LiDAR Quality Assessment Report

WI_MonitowacCo_2015

NGTOC
2017-02-03
Jessica Self

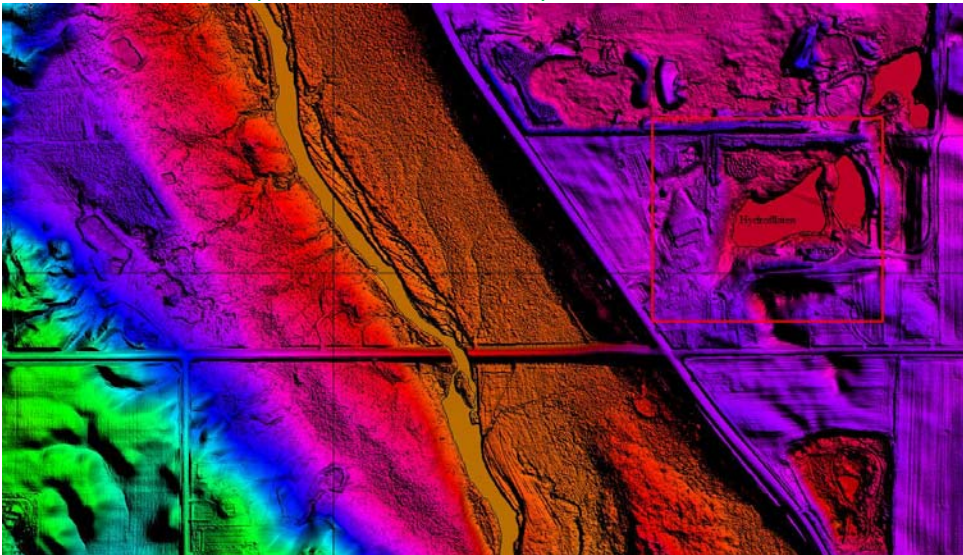
One area needs to be hydro flattened. Water body in 3.22 Acres.

Corrected 5/26/2017

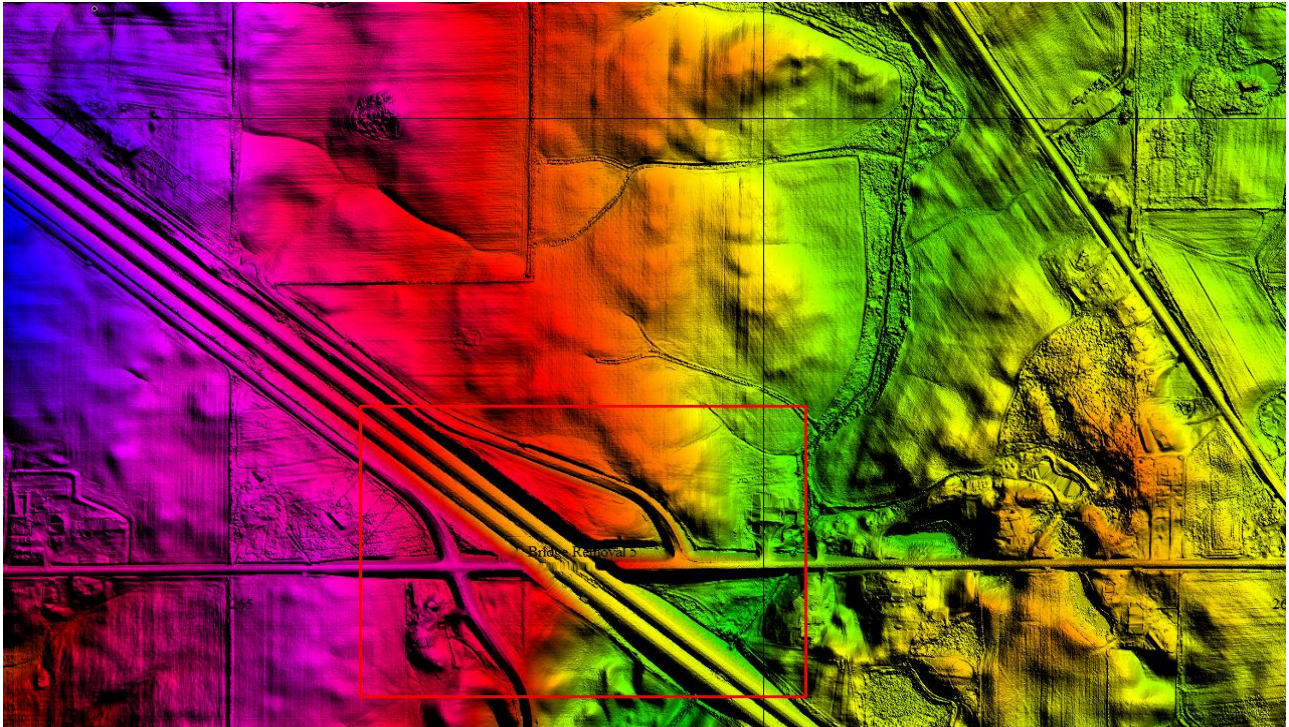
8 Areas need bridge removal.

Corrected 5/26/2017
